Date: 09/28/15  
To: C30HDG-C30HDGWR Series Concrete Pump Owners  
From: Multiquip Product Department  
Subject: Fuse Box Mounting Orientation Modification — **MANDATORY UPDATE**

## C30HDG-C30HDGWR Concrete Pump Fuse Box Orientation Modification

<b>Product Group:</b> Concrete Pump	<b>Date Issued:</b> 09/28/15	<b>Service Bulletin No.</b> PCH20150924
<b>Bulletin Type</b>  <input checked="" type="checkbox"/> Mandatory  <input type="checkbox"/> Information Only  <input type="checkbox"/> Recommended Change	<b>Models/Series Affected:</b> <b>C30HDG CONCRETE PUMP</b> S/N 140702, 140704, 141102, 150103, 140903, 141104, 141103, 140502  <b>C30HDGWR CONCRETE PUMP</b> S/N 141101, 150102, 140802, 150104, 140801, 140901, 14092

**Figure 3. Incorrect Fuse Box Mounting**

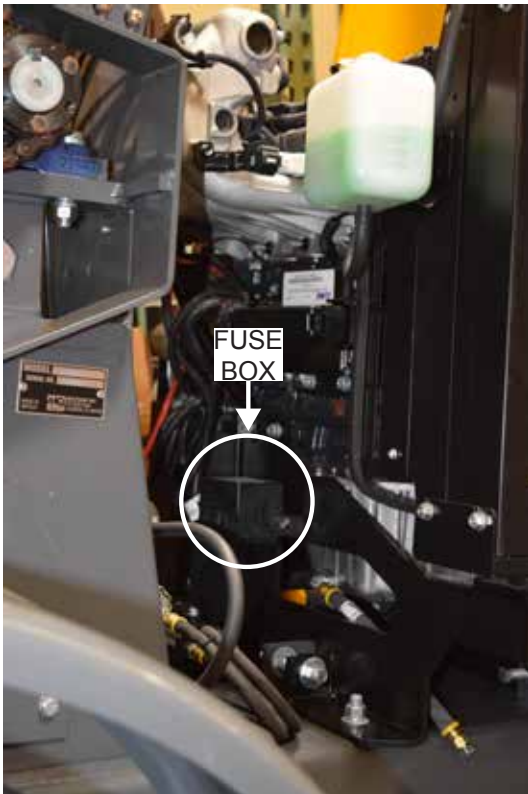
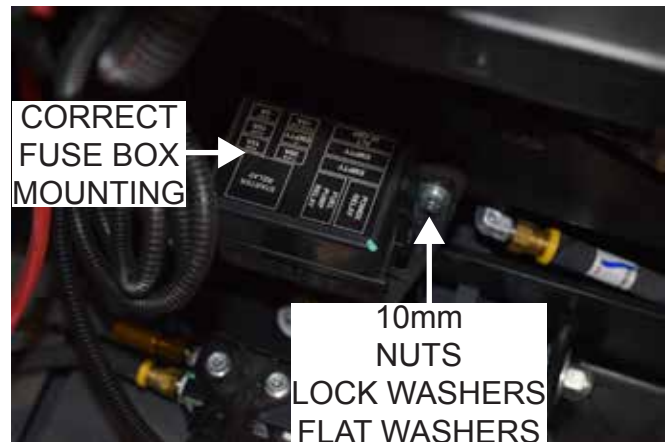
<b>Details</b>
<b>Problem:</b> Some C30HDG and C30HDGWR units may have been shipped with the fuse box incorrectly installed upside down which allows water to be trapped inside the cover causing an electrical system shortage.  <b>Solution:</b> Remove the two 10mm nuts, lock washers, and flat washers and reverse/flip over the fuse box to the correct position.

3. Disconnect the negative cable (**BLACK**) from the negative terminal on the battery.
4. Locate the fuse box in the middle of the unit (Figure 3) and check its mounting orientation. Incorrect fuse box mounting (Figure 4) will have the fuse diagram facing towards the ground.

6. Orientate the fuse box (Figure 5) with the fuse diagram facing upwards. Secure the fuse box using the two 10mm nuts, lock washers, and flat washers.

**Figure 4. Fuse Box Mounting Hardware Removal**

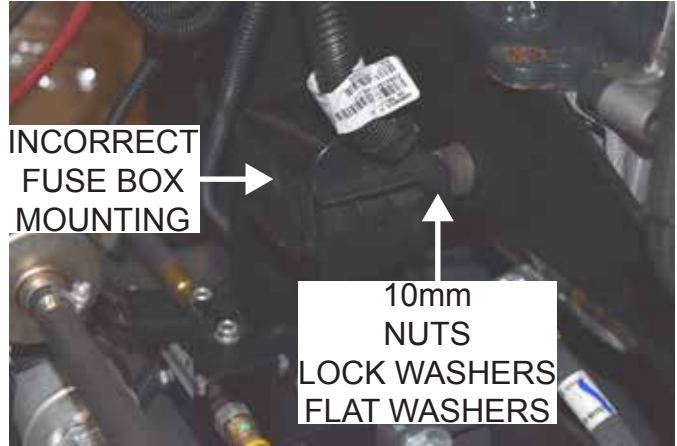
5. If incorrectly mounted, use a 10mm socket to remove the two 10mm nuts, lock washers, and flat washers as shown in Figure 4.
